ATTACHMENT
TO
AECM-84/0338 (6/19/84)

PROPOSED CHANGES TO THE
GRAND GULF NUCLEAR STATION
TECHNICAL SPECIFICATIONS

NRC TECHNICAL REVIEW BRANCH: RADIOLOGICAL ASSESSMENT

FIGURE 5.1.1-1

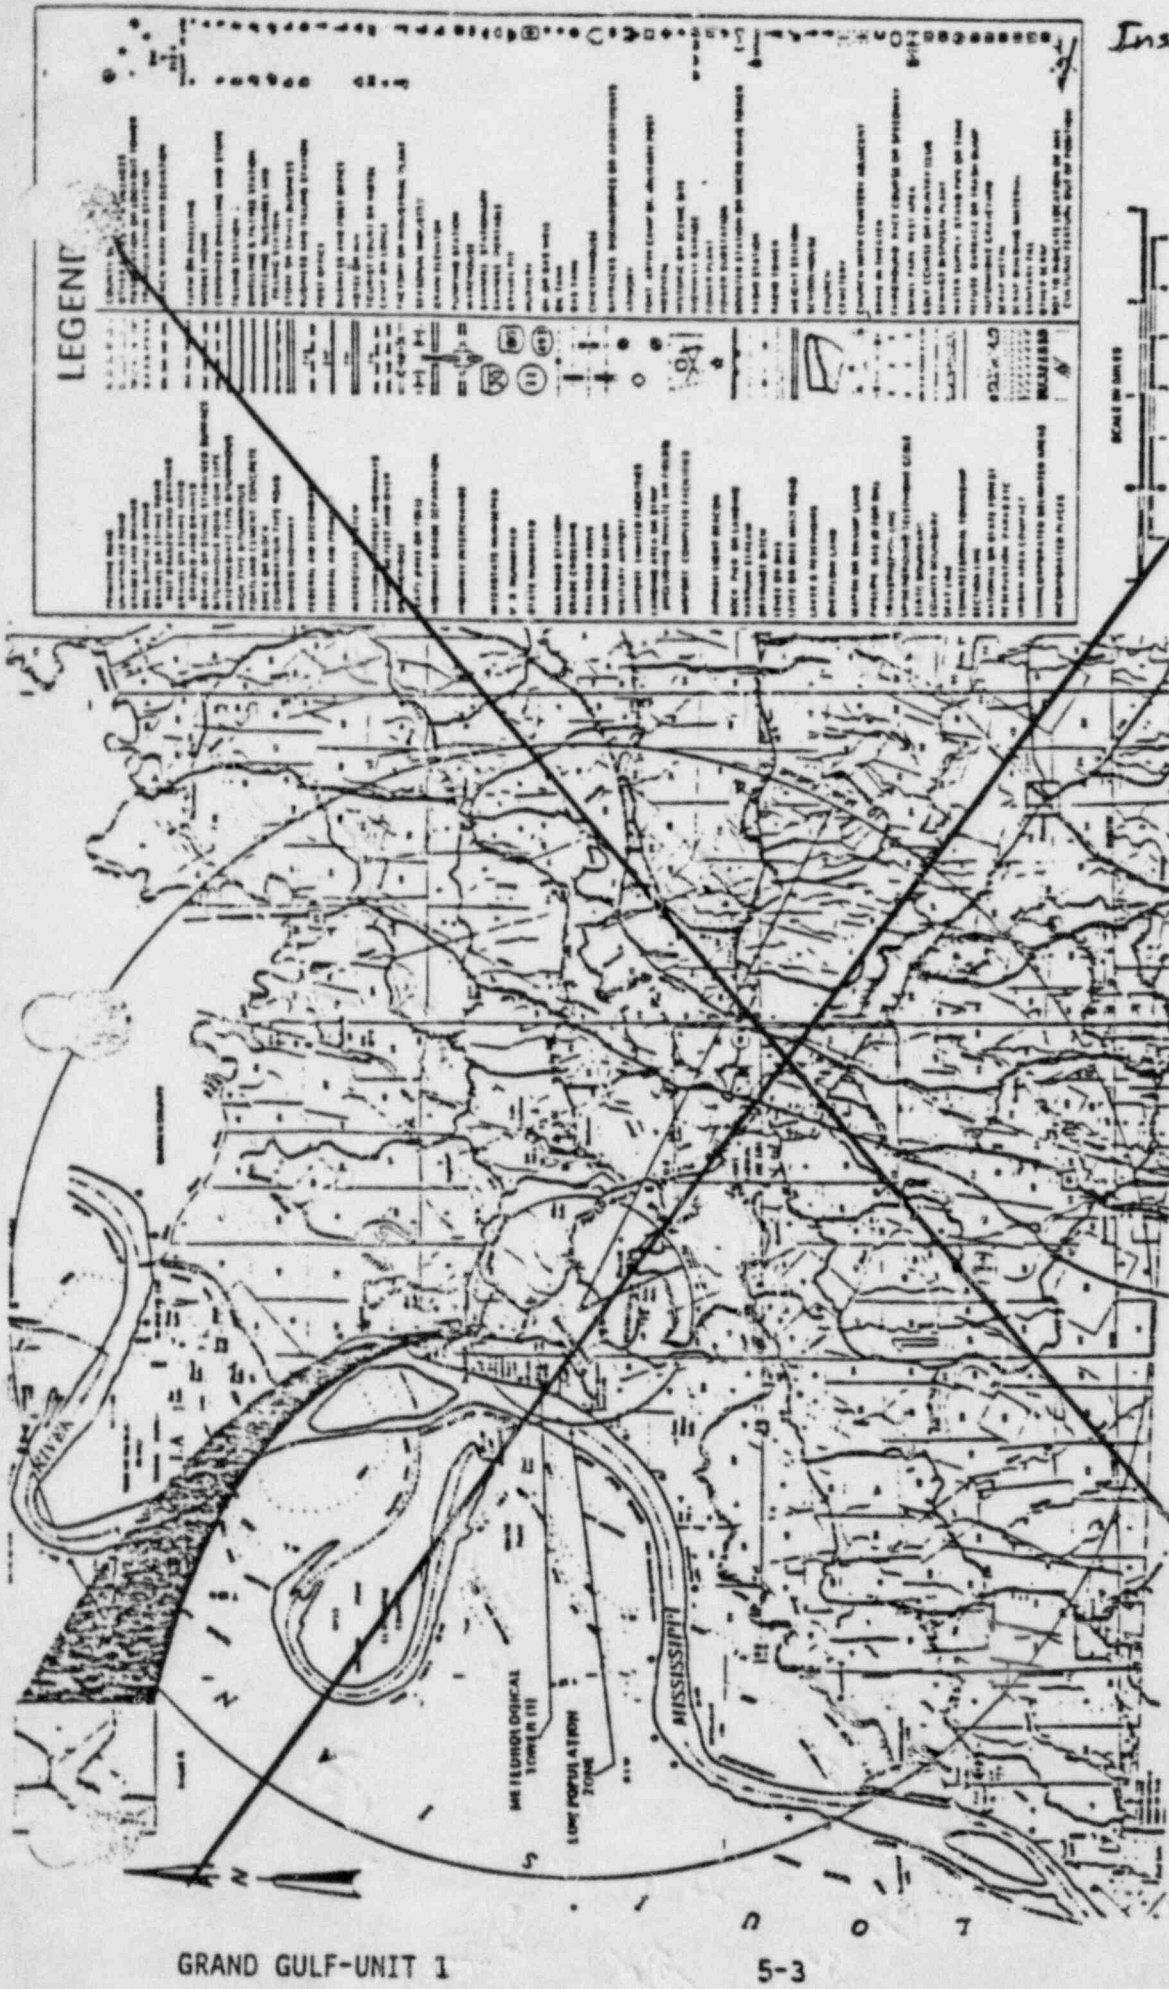
Legible copies of the subject figures are submitted to replace the figures currently found in the technical specifications. All of the subject figures have been redrawn to improve legibility including deletion of typographical lines. These changes are administrative in nature and are submitted in response to NRC concerns over the readability of the subject figures. In addition, Figure 5.1.3-1 has been enhanced by adding the effluent release points. (Pages 5-2, 5-3, 5-4)

5.1.3 ~~The UNRESTRICTED AREA and SITE BOUNDARY~~ The UNRESTRICTED AREA and SITE BOUNDARY for gaseous effluents and for liquid effluents shall be as shown in Figure 5.1.3-1. The gaseous effluent release points are shown in Figure 5.1.1-1.

FIGURE 5.1.3-1

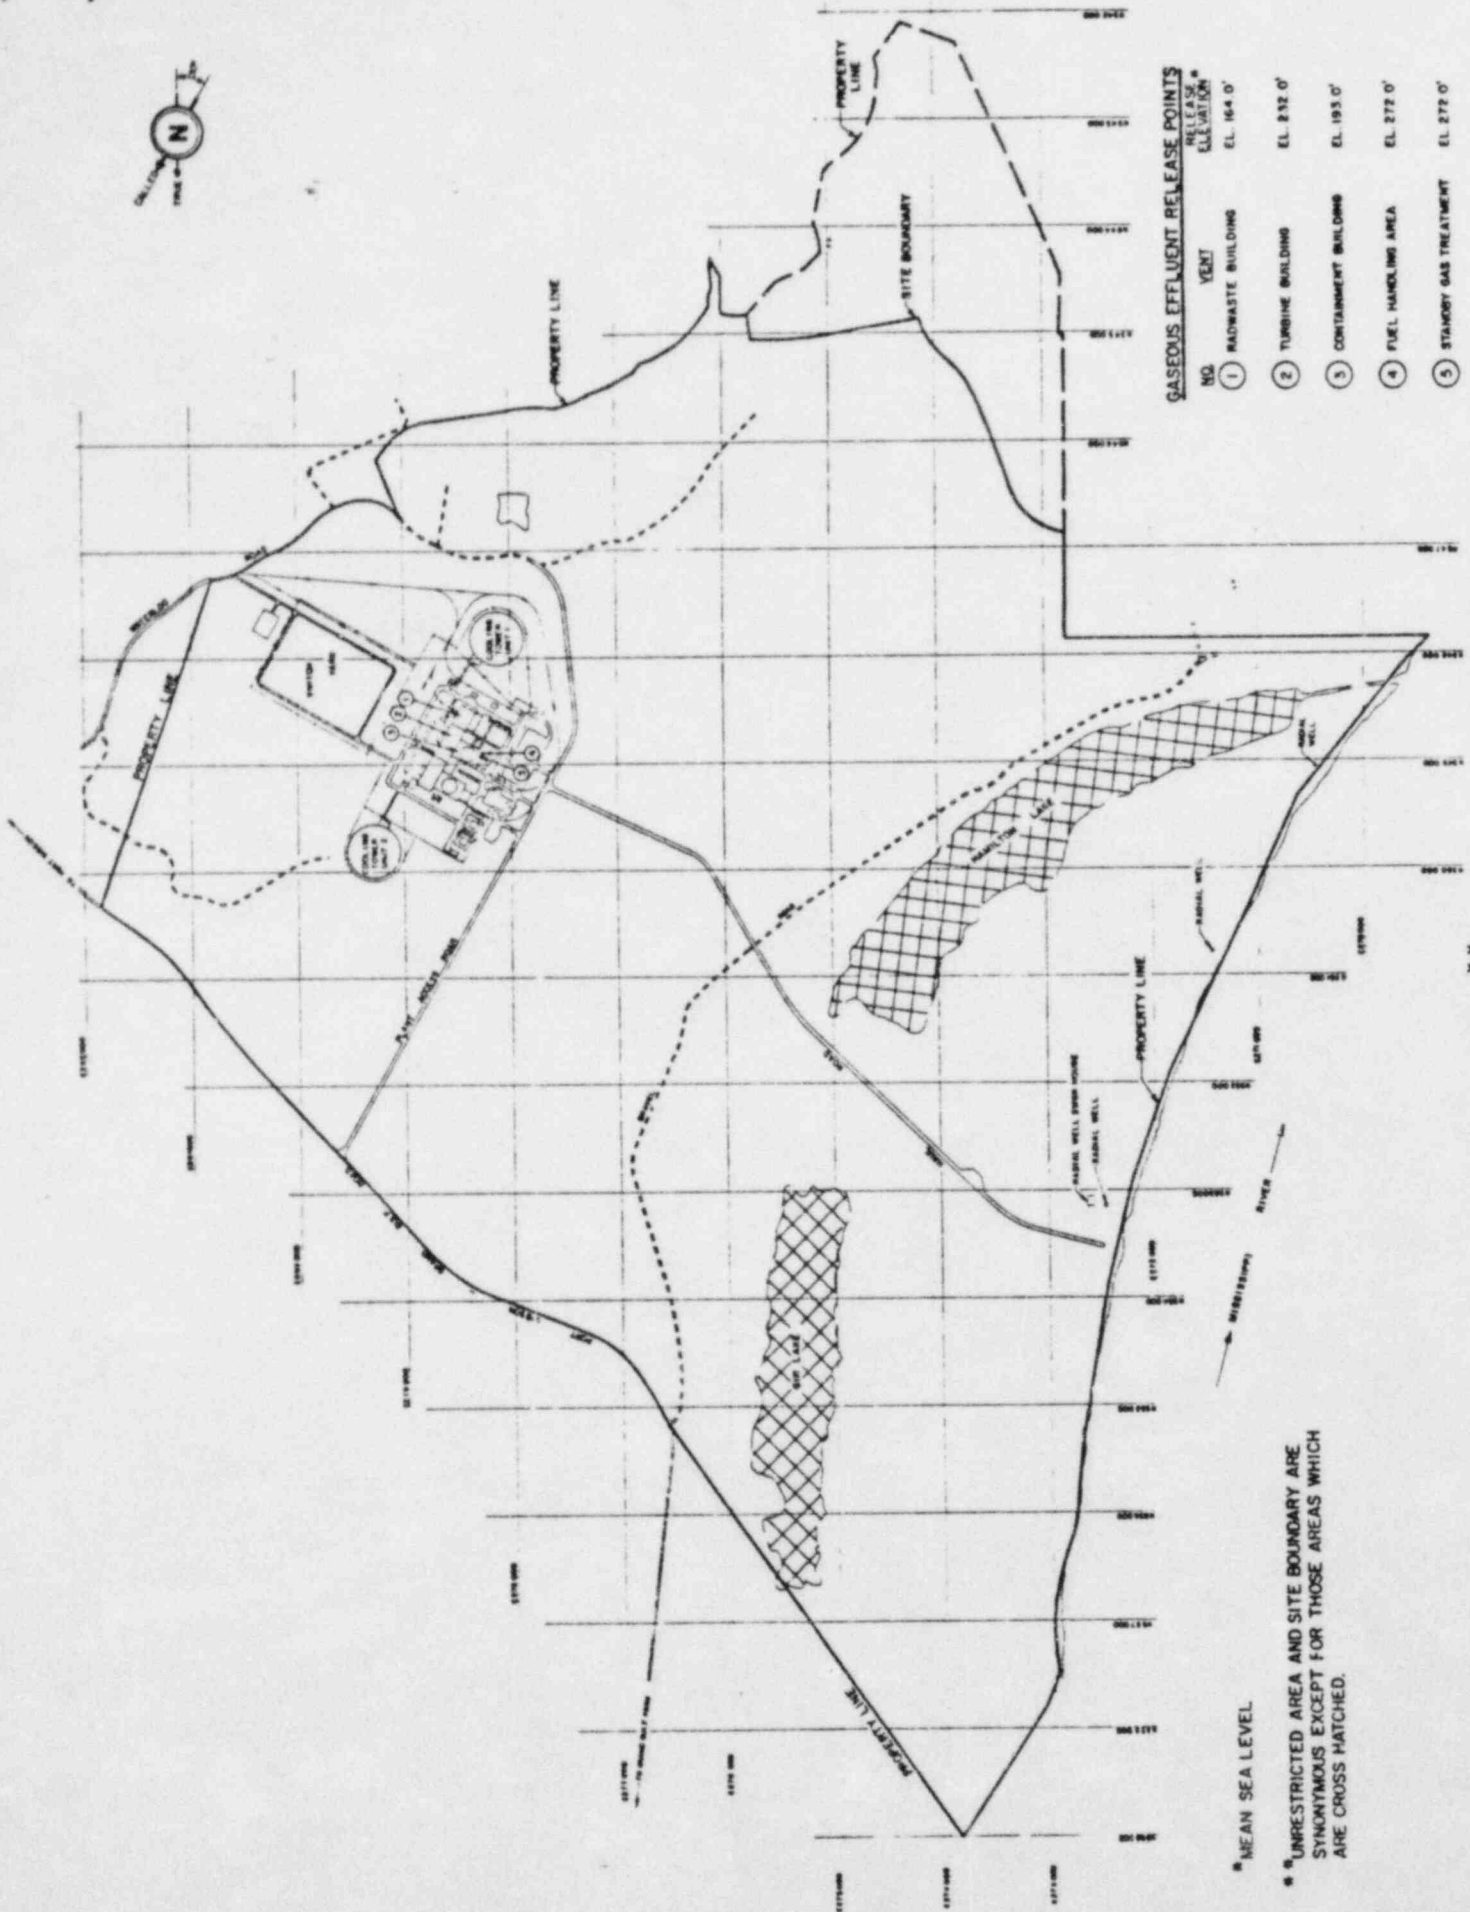
A revision to Technical Specification 5.1.3 is requested to change the "UNRESTRICTED AREA BOUNDARY" terminology in this design feature summary to "UNRESTRICTED AREA and SITE BOUNDARY." This proposed change will achieve consistency throughout the technical specifications with the new definition for UNRESTRICTED AREA and the new definition for SITE BOUNDARY. This proposed change involves no safety significance as it represents a purely administrative change of an editorial nature for the purpose of providing consistency in the technical specifications. (Pages 1-8, 3/4 11-8, 3/4 11-13, 3/4 11-15, 3/4 12-3, 5-1, 6-18, B 3/4 11-2, B 3/4 11-3, B 3/4 11-4, B 3/4 11-5, B 3/4 12-1)
